Department of Environmental Quality

December 20, 2018

Re: Supplemental Information Request  
Response to October 8, 2018 Jordan Cove Correspondence

Jordan Cove Energy Project (FERC Project No. CP17-494)  
Pacific Connector Gas Pipeline (FERC Project No. CP17-495)  
U.S. Army Corps of Engineers (Project No. NWP-2017-41)

Figure 2 of 47 from PCGP's Geologic Hazards Maps (Northwest of Milepost 8R):

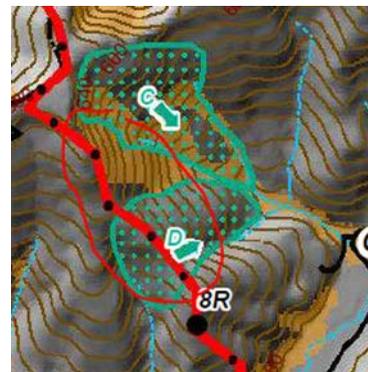
<p>PCGP’s Erosion Control and Revegetation Plan does not indicate if the Temporary Work Area above the unstable slope feature will be used to store spoils (soil, boulders, root wads) and logs from forest clearing. However, PCGP’s Resource Report 1 indicates that PCGP may use these work areas for these purposes. The ECRP does not detail how PCGP will manage construction stormwater above this unstable feature. Stormwater discharge at the top of convergent headwalls and bedrock hollow adds load to the top of this unstable slope. This stormwater discharge may create a positive soil pore pressure leading to a landslide. PCGP has not provided DEQ with an engineered post-construction stormwater management plan for the permanent pipeline right-of-way for this area and others indicating how PCGP will manage drainage above unstable slope features.</p> <p>On page 35 of Resource Report 6, PCGP discusses two primary ways in which pipeline construction has the potential to adversely impact slope stability. PCGP notes in Report 6 that routing drainage to potentially unstable slopes has the potential to adversely impact slope stability. However, PCGP does not provide DEQ with an analysis using the slope stability models to identify unstable slopes noted in DEQ’s review of PCGP’s response to Comments 6 and 7. Additionally, PCGP does not provide DEQ with a construction and post-construction stormwater management plan demonstrating how specifically PCGP will manage stormwater along these unstable landscape features.</p> <p>PCGP only identifies slope breakers along the construction and permanent right-of-way as the only technique to manage construction and post-construction stormwater. PCGP does not discuss, for example, or demonstrate the application of cutoff trenches presented in technical manuals on stabilizing slopes. PCGP does not detail the grade and placement of slope breakers on the ground in engineering plans for the construction and permanent right-of-way. Without this information as well as the drainage pattern, DEQ is unable to determine if the proposed use of slope breakers alone is sufficient to prevent the addition of weight from stormwater and an increase in soil pore pressure on an unstable slope.</p> <p>With the current submittal, DEQ cannot determine if the proposed slope breakers highlighted in the Erosion Control and Revegetation Plan will prevent landslides due to pipeline construction and operation. Additionally, in Resource Report 6 and the proposed ECRP, PCGP does not address site-specific constraints (i.e., roads, unstable landforms on each side of the right-of-way etc.) that may limit the application of slope breakers to route drainage away from unstable slopes. PCGP is proposing to remove trees and shrubs to install this gas pipeline. This loss of tree interception will increase the volume of runoff generated along pipeline’s construction and permanent right-of-way. The discharge of this additional runoff among these unstable slope features has the potential to impact water quality.</p> <p>The following are two more examples highlighting similar concerns discussed in DEQ’s review immediately above.</p>

Figure 2 of 47 (Northwest and South of Milepost 10R) – Area No. 115 delineated in red is an identified landslide from the Department of Geology and Mineral Industries:

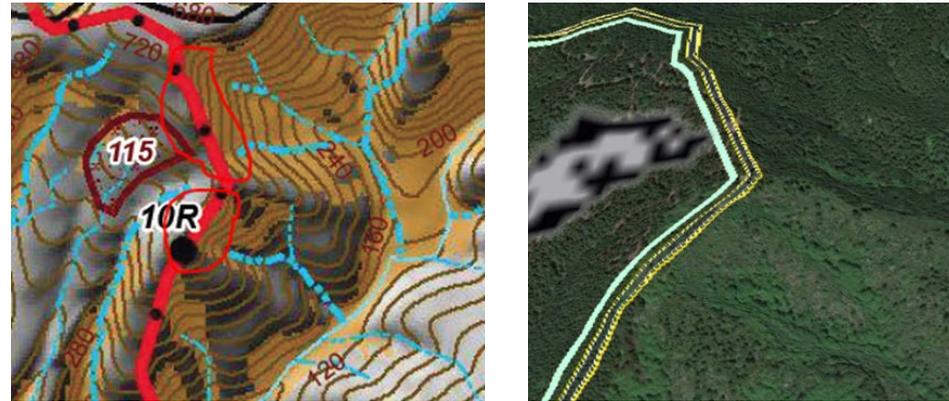
PCGP's ECRP does not show the engineering analysis and its technical support for how PCGP will manage the construction and post-construction stormwater above the Area of a Rapidly Moving Landslide Hazard and convergent headwall as well as the mapped landslide 115 identified by the Oregon Department of Geology and Mineral Industries..

Figure 4 of 47 (Southeast of Milepost 17 BR) – Blue square is a hydrostatic test location while the magenta polygon is an uncleared storage area:

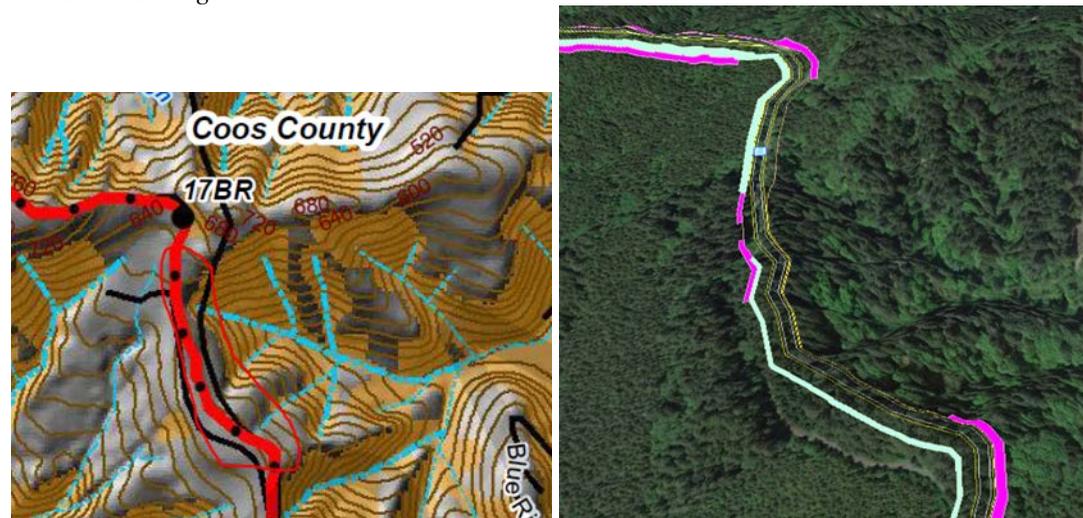
PCGP’s ECRP does not show the engineering analysis and its technical support for how PCGP will manage the construction and post-construction stormwater above the Area of a Rapidly Moving Landslide Hazard and convergent headwall.

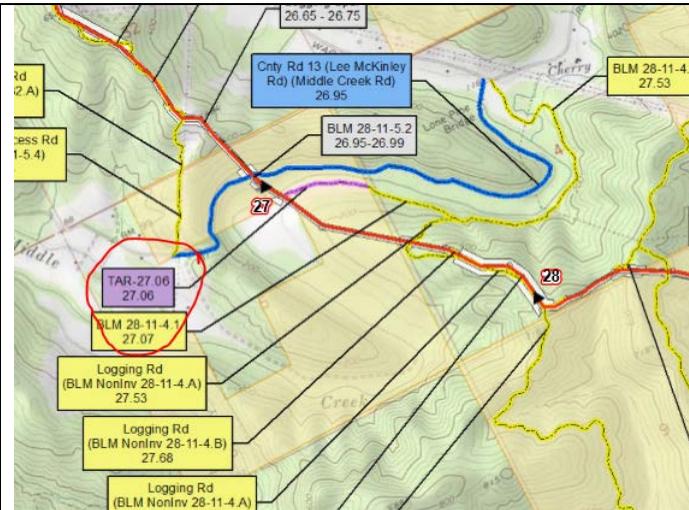
In issuing treatment prescriptions based on PCGP’s road inventory requested in DEQ’s review of PCGP’s response above, DEQ expects PCGP to provide the detailed maintenance standards and specifications that PCGP will use for all identified treatments.
25	<p>Identify the location of all existing roads that PCGP will use to access the gas pipeline during its operation. Provide a maintenance plan for these existing roads that includes:</p> <ul style="list-style-type: none"> <li>• A description of the level of use these roads will experience during the pipeline’s operation.</li> <li>• A description of the maintenance practices to protect water quality and a schedule for performing these practices and supporting this level of use.</li> </ul>	<p>Outside of federal lands, PCGP’s use of public roads are not subject to federal licensing or permitting, and therefore no certification is required under Section 401. PCGP is not required under federal or state law to prepare operations and maintenance plans to use public roads. PCGP anticipate employing less than 15 operational staff. The operation traffic will be incidental to the existing traffic on existing road.</p>	<p>DEQ will review all proposed project-related activities that require a federal permit or permits and that may cause or contribute to a discharge to waters of the state. OAR 340-041-0007(7) and 340-048-0042(2) authorize DEQ to require maintenance plans to address discharge from temporary and permanent roadways. This includes permanently maintained access roads to service portions of the pipeline and its aboveground facilities. Given their potential to impact water quality through sediment discharge, DEQ is particularly concerned with the maintenance and operations planning for non-paved PARs when PCGP’s uses these roads for pipeline repair and reconstruction given the heavy equipment traffic associated with these activities.</p>

Location of TAR 27.06 near Milepost 27 on the General Location Maps. Drawing No. 3430.31-Y-Map 5, Sheet 6 of 55

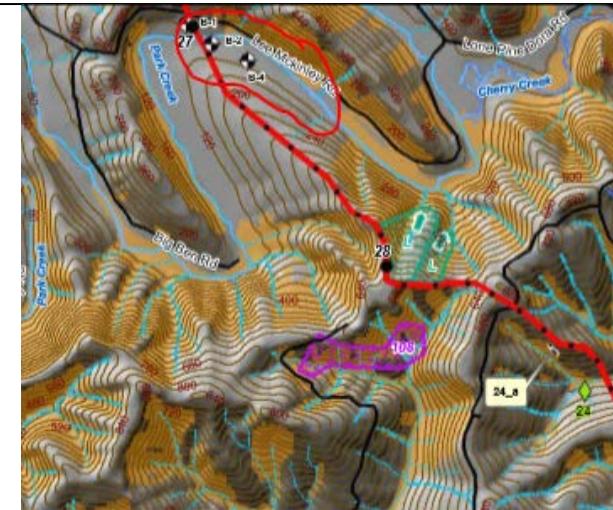
<p><i>the development of the engineering design. The order in which the techniques are listed in the table, and described in Section B2-F5, is the approximate order in which they should be applied.</i></p> <p><i>B1.2.4 Road Operation and Maintenance</i></p> <p><i>During road operation and maintenance, the focus of attention will be directed towards existing cut and fill slopes and the management of drainage. Systematic routine observation, slope monitoring and condition surveys will form the basis of the records necessary for ongoing assessment of slope stability. Field mapping, cross-section survey and ground investigation or monitoring at high-risk site may be required for the reinstatement and remedial works for slopes and section of road that have failed (Part D).</i></p> <p>Hearn’s recommendations for road construction, operation, and maintenance serve as one of several reasons for DEQ’s request for additional information in Comment 26 and 27. Such recommendations and applicable regulatory requirements also serve as the basis for DEQ’s information request in Comment 24. Hearn’s recommendations provide examples of the information DEQ expects PCGP to provide DEQ when furnishing information on its maintenance plans for both Permanent Access Roads and existing access roads. Since PCGP needs access roads for PCGP’s operation of the pipeline and the controlling authorities for these access roads cannot decommission these roads to avoid their associated water quality risks, these roads present potential impacts to water quality that PCGP must address in its 401 Water Quality Certification submittal. As a result, for access roads on steep and/or unstable slopes necessary for pipeline operation, PCGP must provide a maintenance plan that periodically evaluates the influence of these access roads on slope stability and evaluates the need to adjust the road design to help maintain the stability of the slope below and above the PAR.</p> <p>For another example of the lack of information provided by PCGP for proposed PARs and TARs, PCGP proposes to build Temporary Access Road labeled TAR 27.06. This TAR parallels the stream Park Creek and would extend a BLM road (BLM 29.11-4.1 27.53) when County Road 13 is also available to reach the temporary extra work area near Milepost 27. PCGP does not provide information detailing how PCGP will manage drainage from this proposed new access road and the extent, condition, or existence of a vegetated buffer between TAR 27.06 and Park Creek. PCGP does not provide information on the design of the cut slope for this TAR nor indicate with designs and technical support how PCGP will stabilize this cut slope to prevent small slides into the roadside stormwater conveyance system or perhaps prevent larger slides conveying debris flows into Park Creek directly. PCGP does not provide a discussion of the other alternatives to reach this TEWA. PCGP does not provide the rationale for building this new access road nor does PCGP provide the design details for DEQ to evaluate if this design has the potential to protect water quality.</p>

Location of PAR-113.66 and the reconstruction of BLM Noninv 32-2-36.A. Drawing No. 340.31-Y-Map 14, Sheet 32, 55

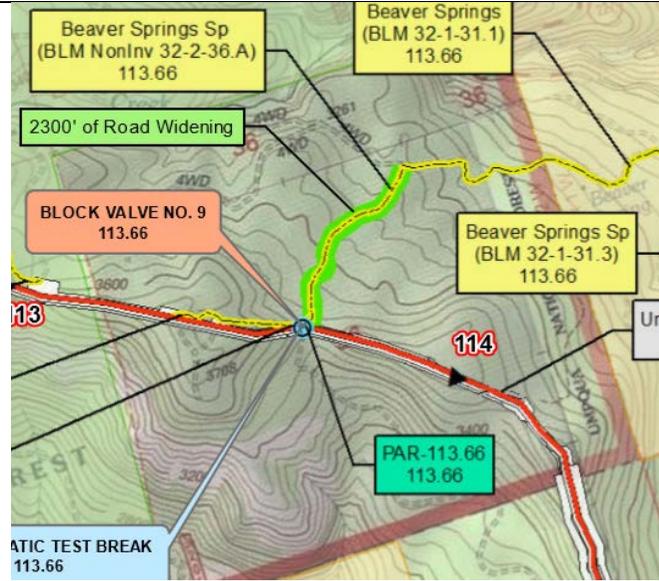
PCGP is proposing to site another proposed new road labeled as PAR-132.66 and shown in the map excerpt below. PCGP proposes to locate this PAR in a Potential Rapidly Moving Landslide Hazard Area. This proposed PAR is also near landslides identified from Aerial Photos and from LiDAR. Moreover, PCGP is proposing to reconstruct BLM's Beaver Springs road (BLM Noninv 32-2-36.A) by widening it. According to PCGP's Geologic Hazard Map, this BLM road identified for widening is located above a landslide area that drains to intermittent stream discharging into Dead Horse Creek. PCGP has not provided DEQ with design information regarding the need for the creation of fill slopes for this proposed new road in an area with unstable slopes. PCGP has not provided DEQ with design information for the reconstruction of the BLM road above unstable slopes. Has PCGP conducted a geotechnical investigation of this road-widening project? If performed, does this geotechnical investigation indicate the need for reinforced fill for this road-widening project? Where will PCGP discharge the post-construction stormwater for this PAR? Given the lack of design details, these questions surface for DEQ while reviewing PCGP's submittal.

Section 4.2.2 on Slope Breakers from PCGP’s Erosion Control and Revegetation Plan Drawing Number 3430.34-X-0008 of Slope Breakers

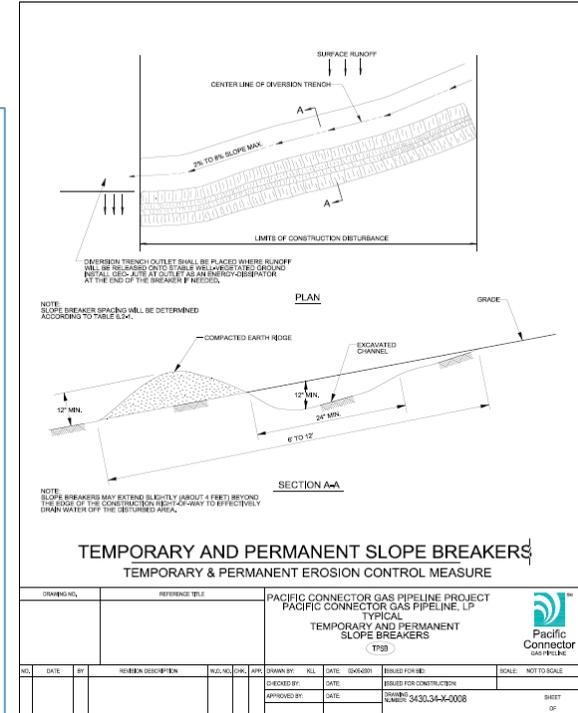
- If PCGP will setback slope breakers from the ordinary high water mark to comply with Corps and DSL permit requirements, how will the discharge from these slope breakers prevent hydromodification of smaller streams and, therefore, bed and bank erosion in these streams with its effect on Oregon’s biocriteria?

DEQ is seeking answers to the questions above because PCGP has provided limited information on its proposed post-construction stormwater controls at the stream crossings of the permanent right-of-way. In Comment 34, DEQ requested PCGP use DEQ’s [Section 401 Water Quality Certification Post-Construction Stormwater Management Plan Submission Guidelines](#). Using these guidelines would provide DEQ with information needed to evaluate the efficacy of PCGP’s proposed use of slope breakers at stream crossings. For example, PCGP is proposing to discharge stormwater from slope breakers and, presumably, infiltrate this discharge into the surrounding soils for treatment. According to DEQ submission guidelines for a post-construction stormwater management plan, the PCGP should design structural controls for any conditions that warrant special water quality considerations such as:
